ITEM: 6.11	COMMITTEE OF ADJUSTMENT REPORT SUMMARY MINOR VARIANCE APPLICATION FILE NUMBER A063/23 170 ARNOLD AVE, THORNHILL
-------------------	--

**COMMITTEE OF ADJUSTMENT REPORT
MINOR VARIANCE APPLICATION
A063/23
170 ARNOLD AVE, THORNHILL**

ITEM NUMBER: 6.11	CITY WARD #: 5
APPLICANT:	Noah Tenser & Clara Serruya
AGENT:	Weston Consulting (Ryan Guetter & James Todd)
PROPERTY:	170 Arnold Ave, Thornhill
ZONING DESIGNATION:	See below
VAUGHAN OFFICIAL PLAN (2010) DESIGNATION:	Vaughan Official Plan 2010 ('VOP 2010'): "Low-Rise Residential"
RELATED DEVELOPMENT APPLICATIONS:	None
PURPOSE OF APPLICATION:	Relief from the Zoning By-law is being requested to permit a proposed single family dwelling, cabana and two driveways.

SITE PLAN
SCALE 1/32" = 1'-0"

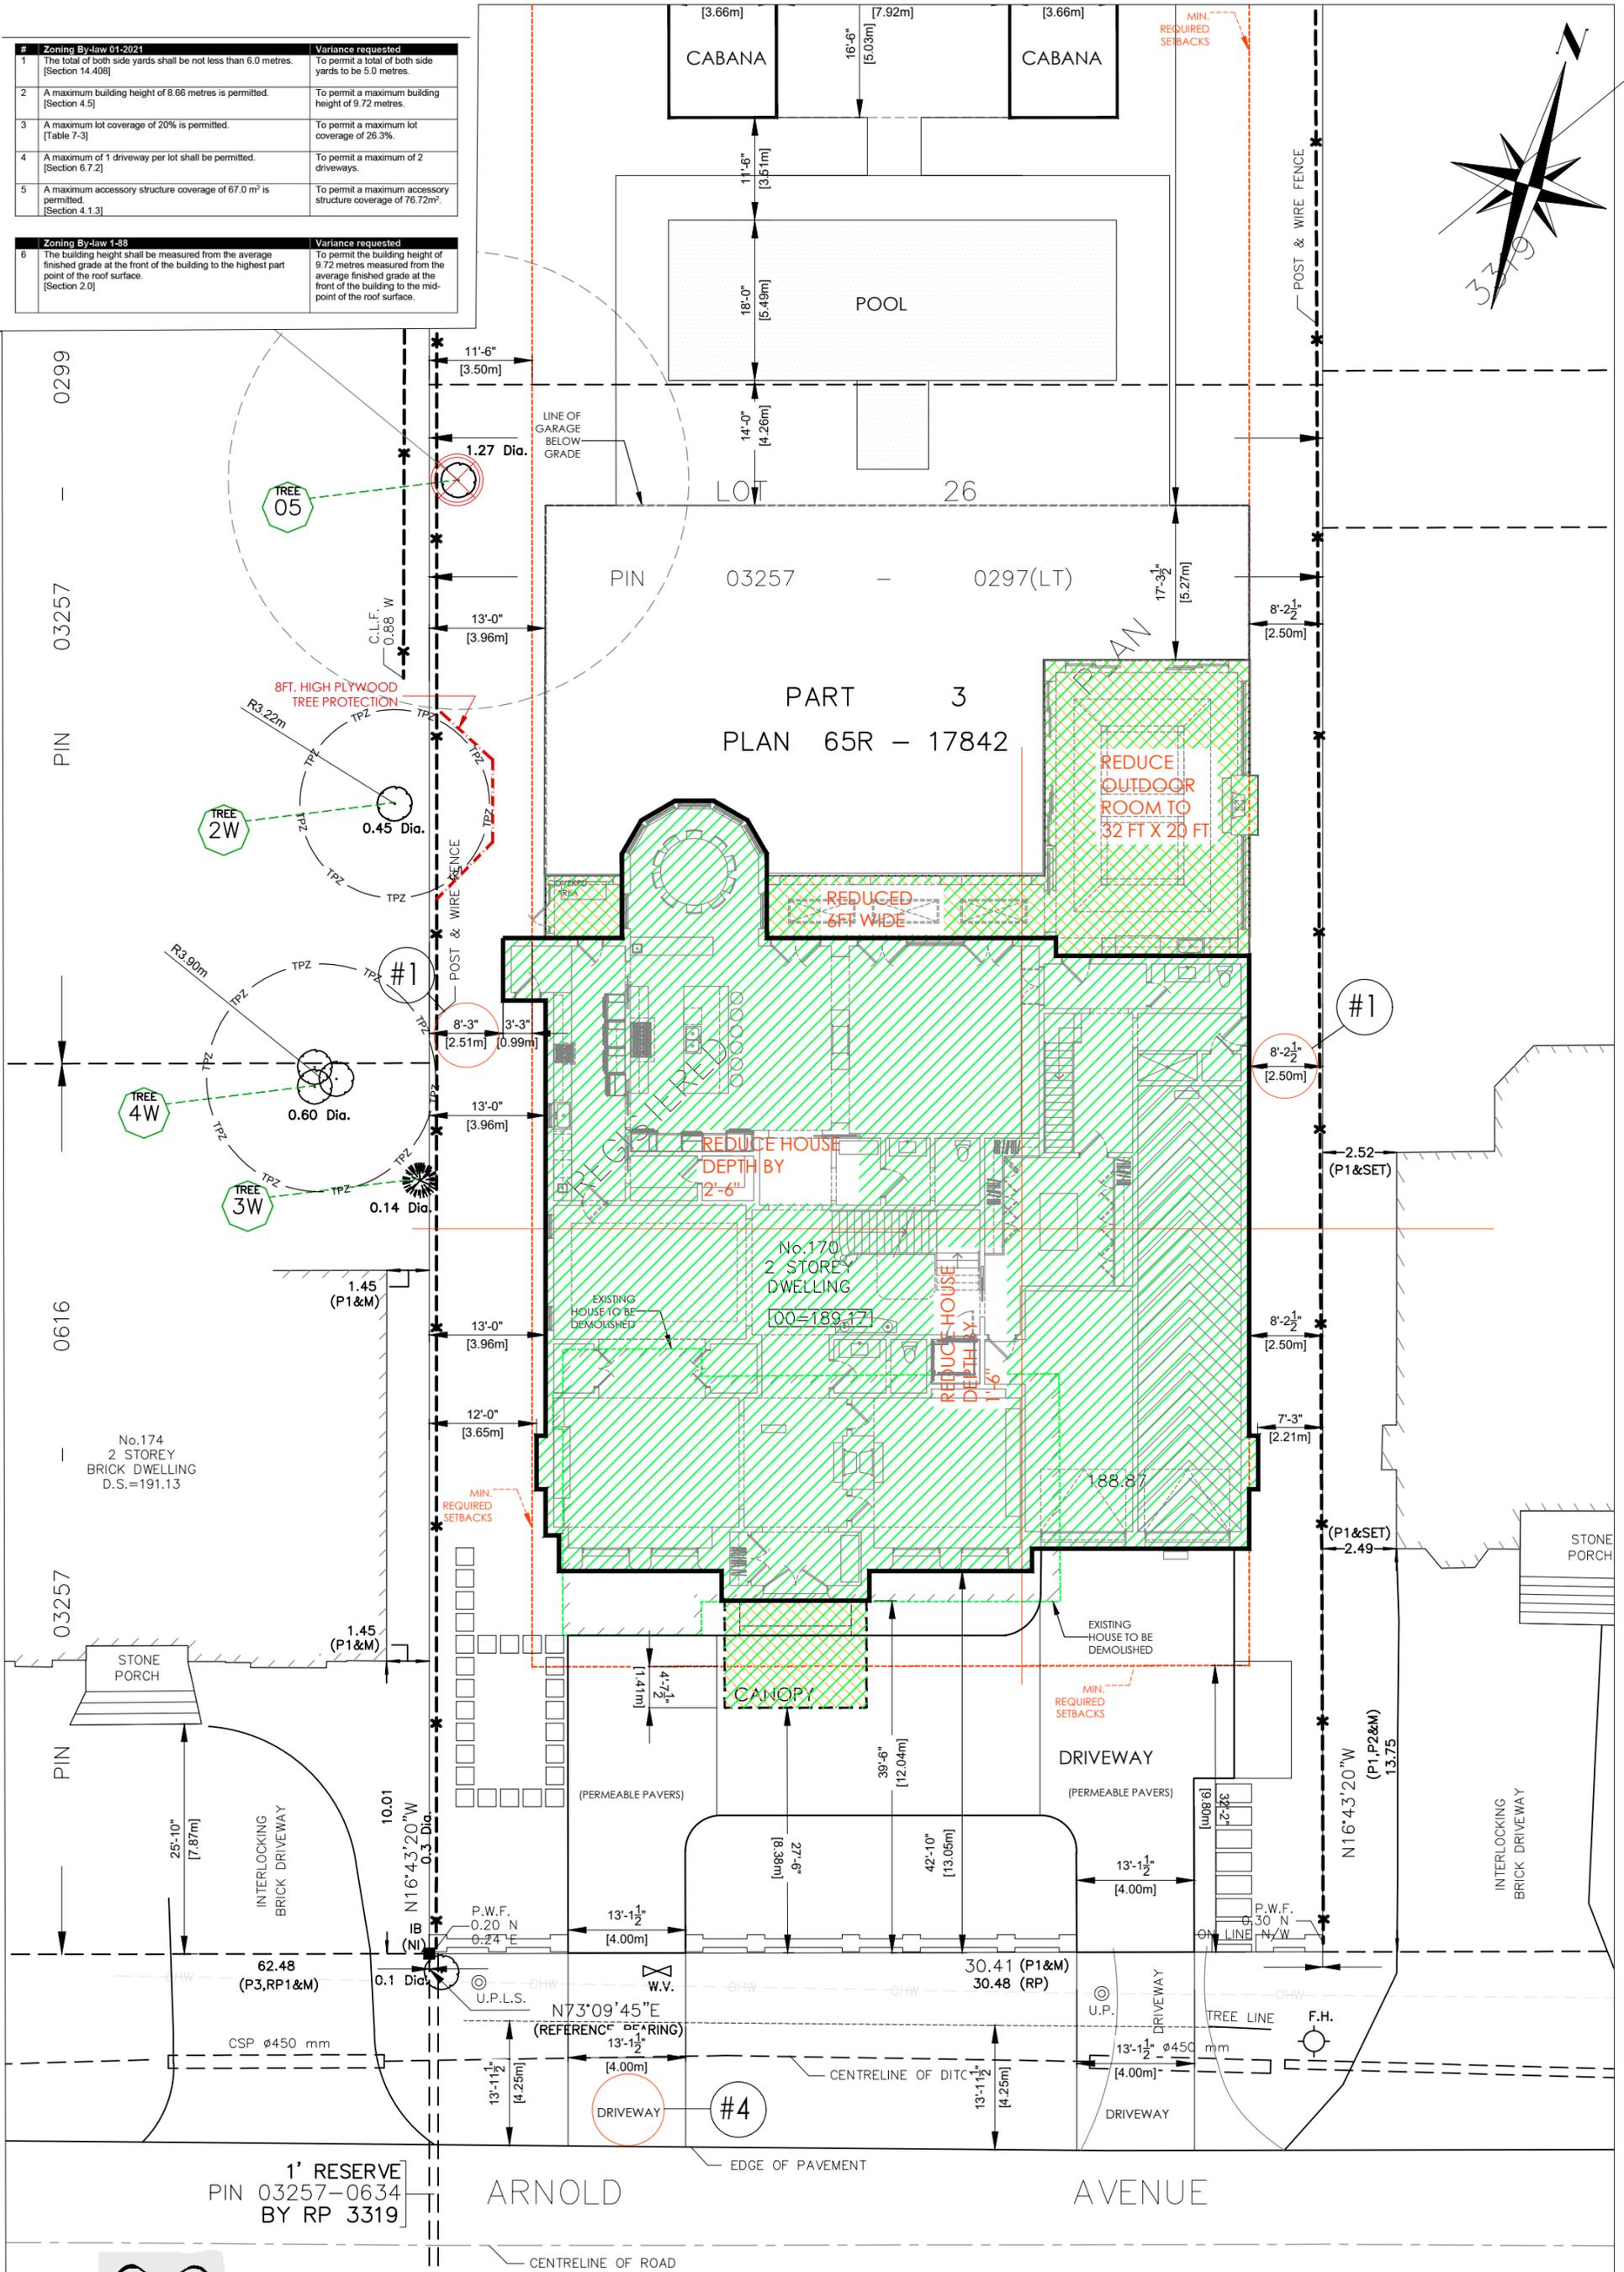
Development Engineering (DE) staff reached out to the applicant and discussed concerns regarding a potential for increased stormwater runoff caused by the 6.3% additional hardscaping. To address this concern, the Applicant revised their proposal to include permeable paver walkways to reduces surface runoff.

LANDSCAPE
CALCULATION

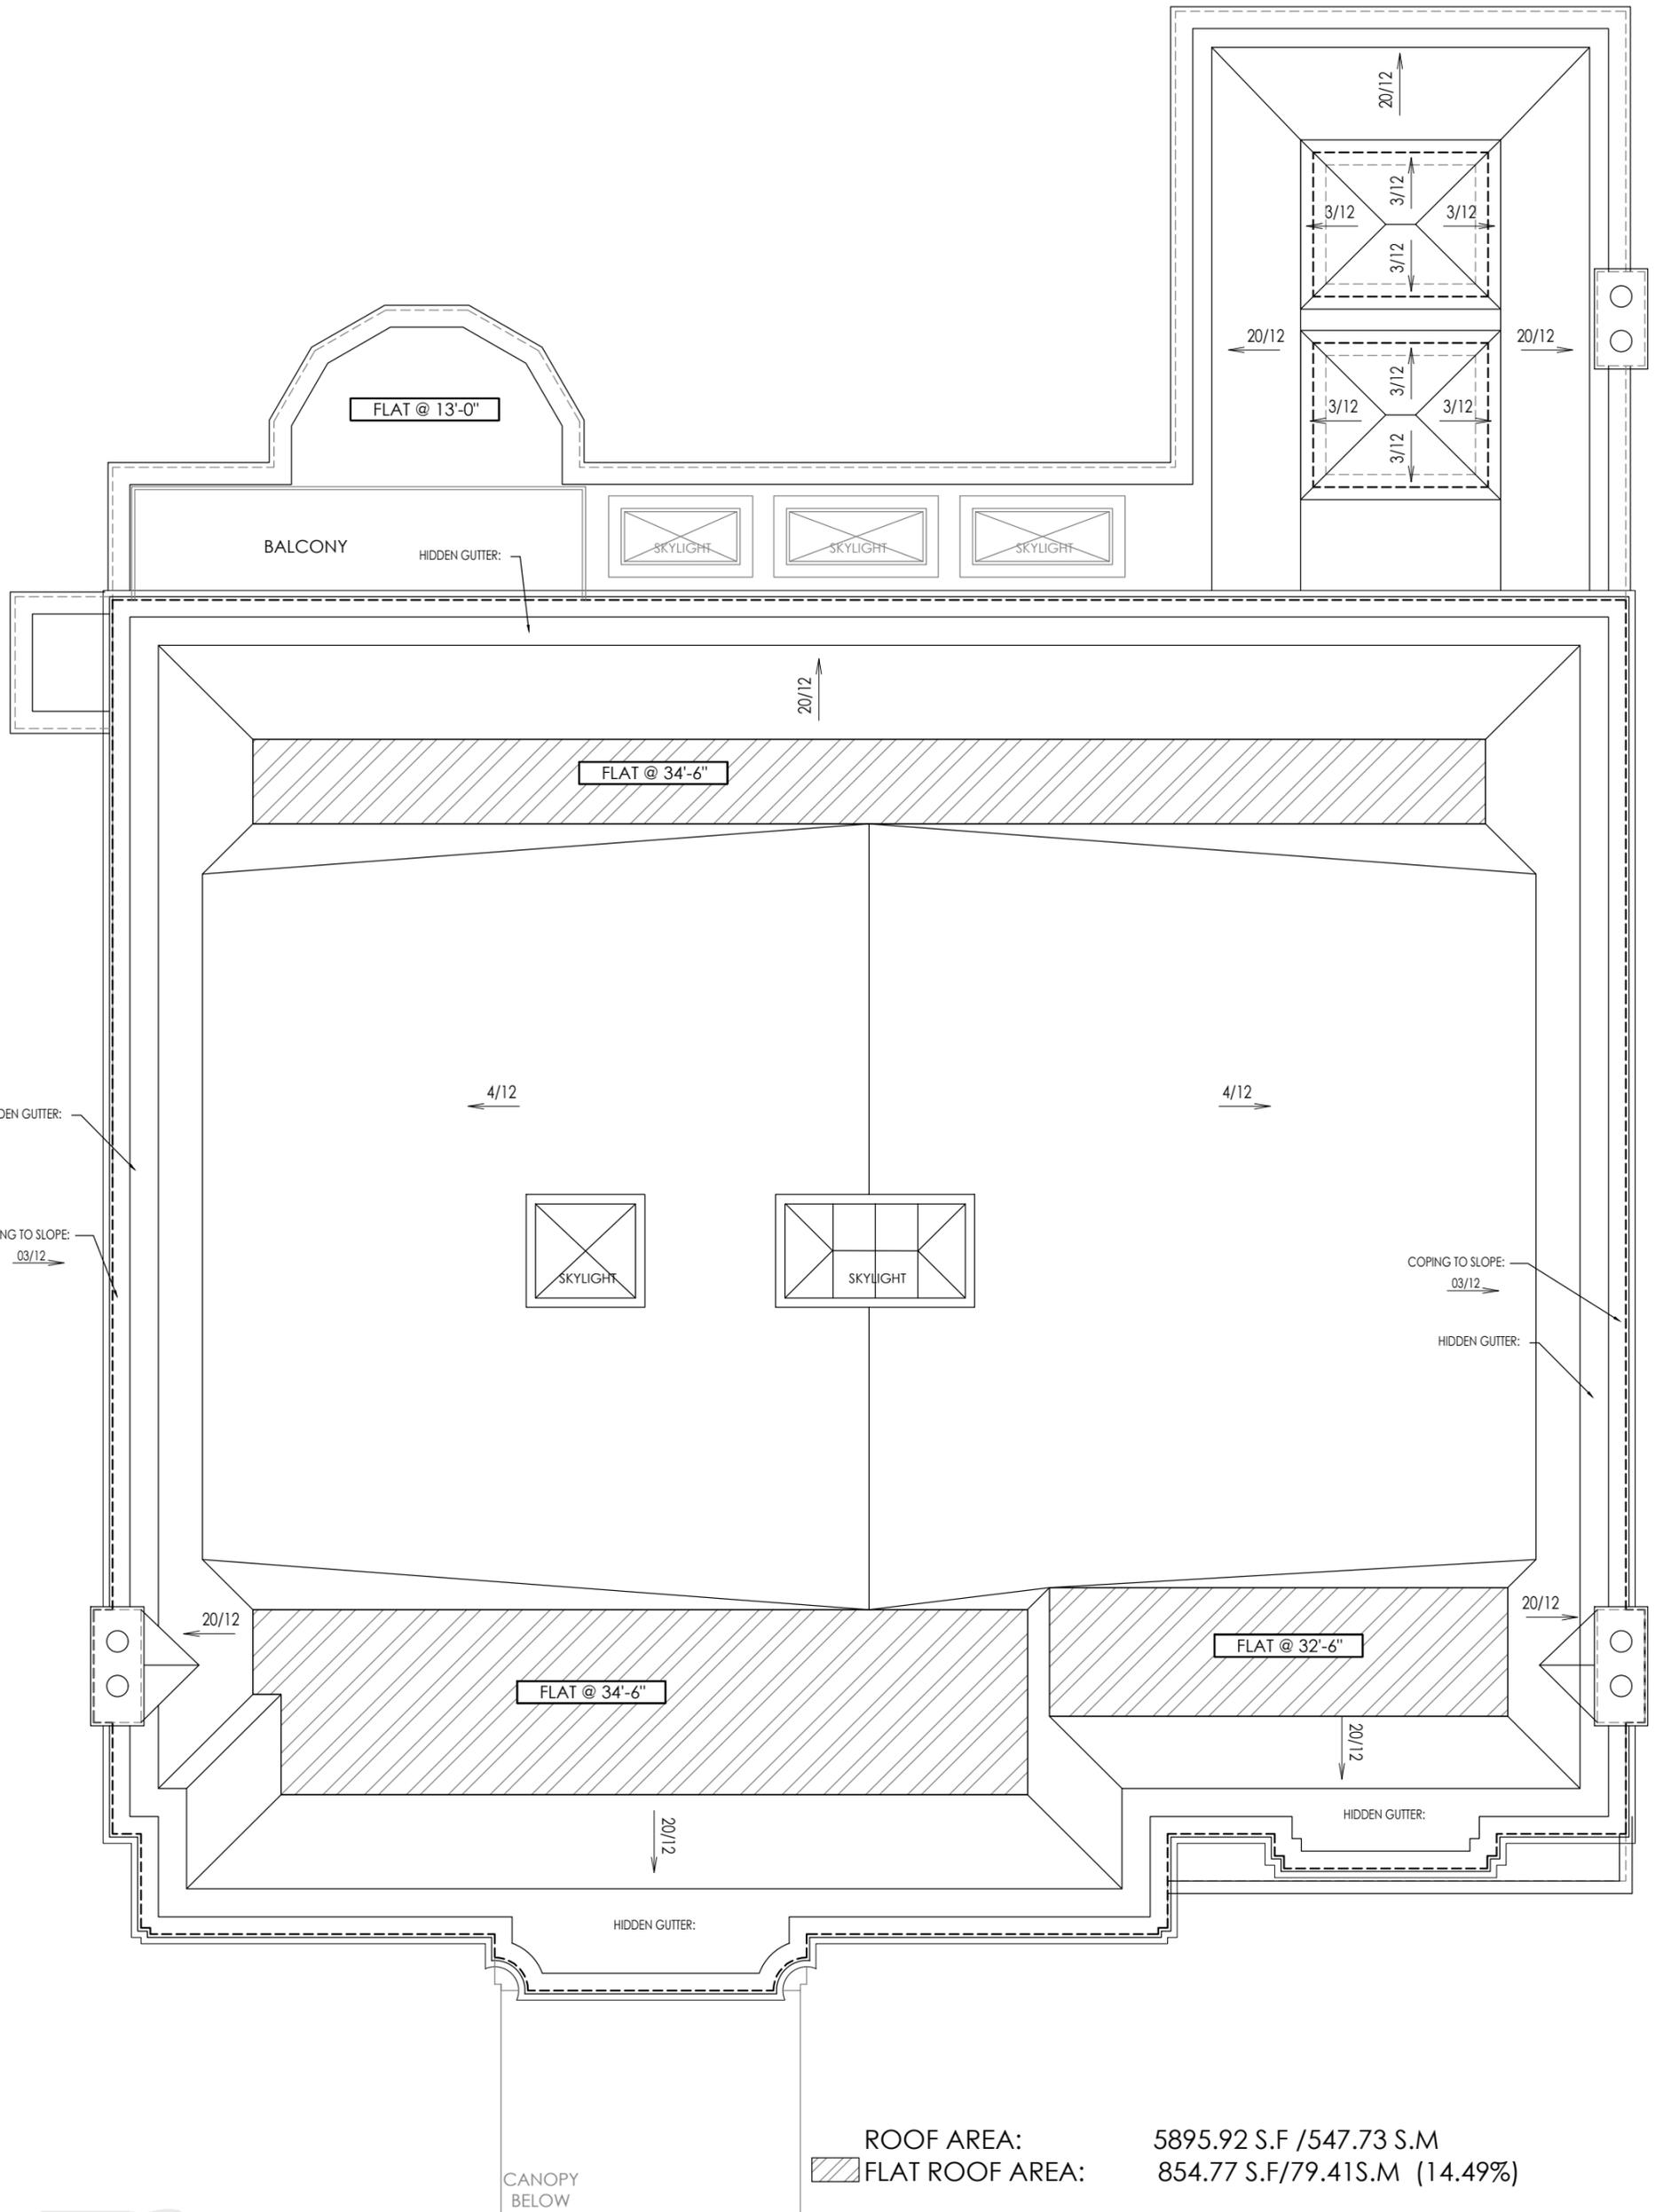
Zoning By-law 01-2021	
1	A maximum driveway width of 9.0 metres is permitted [Table 6-11]
2	The minimum required front yard setback is 8.88 metres based in accordance with Section 4.5. Canopies are permitted to encroach a maximum of 0.6 metres into the required front yard.
3	The canopies are not considered accessory structures and shall not be included in the accessory structure coverage calculation.
